S  
**ENGINEERING CHANGE NOTICE**

1-ECN: 648541

# COMMERCIAL GRADE ITEM DEDICATION FOR LEAK DETECTION RELAYS

HNF-4275  
REVISION 3

LEAK DETECTOR CONTROL DIAGRAM  
SKETCH 2  
PAGE 15 OF 15

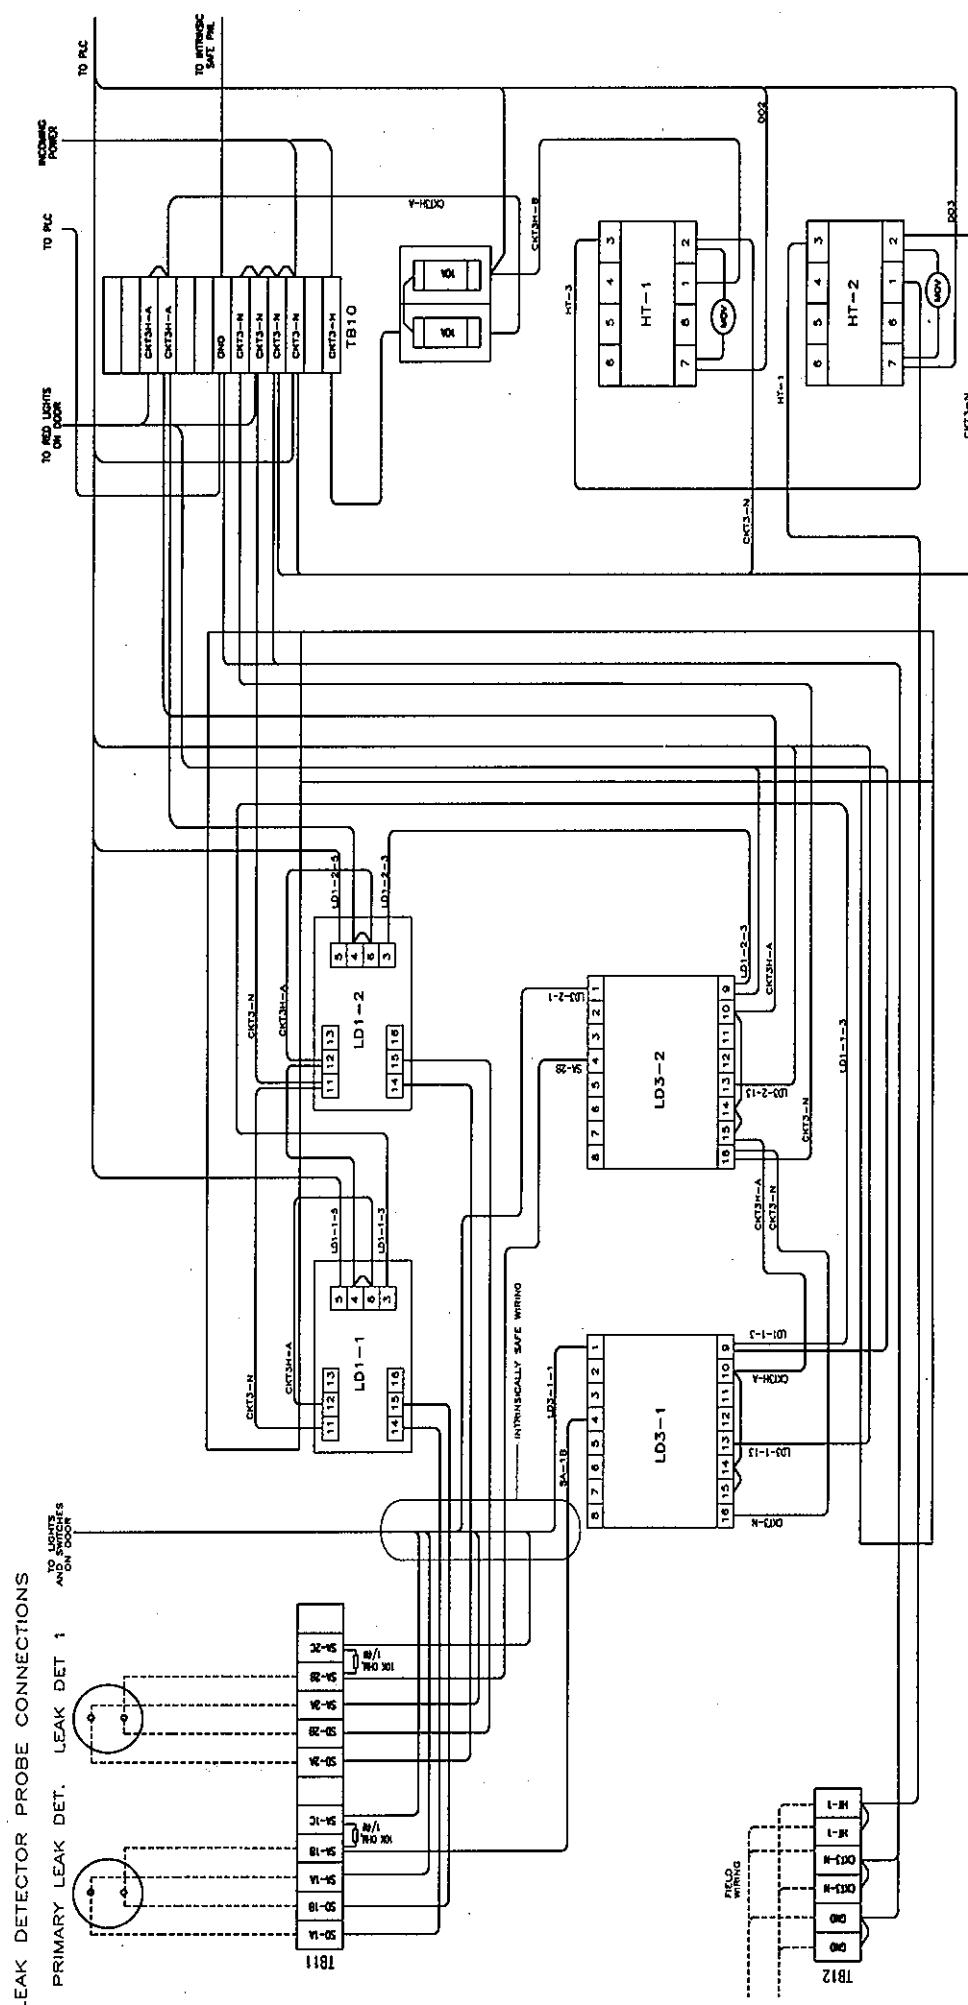
This ECN is a direct revision of document HNF-4275, Commercial Grade Item Dedication for Leak Detection Relays. The revision changes steps 6.1.5 through 6.1.27 and adds steps 6.1.28 through 6.1.42. Step 6.2.1, is changed and steps 6.2.19, 6.2.23, 6.2.27, 6.2.31, 6.2.35, 6.2.39, and 6.2.43 were added to section 6.2. The references in section 12 were updated. The data sheets and sketches were changed to reflect the changes in the steps in sections 6.1 and 6.2.

- 6.2.14. Remove the 120vac power from the leak detector assembly.
- 6.2.15. Connect a leak detector probe to the leak detector terminal block as shown in the attached sketch 2.
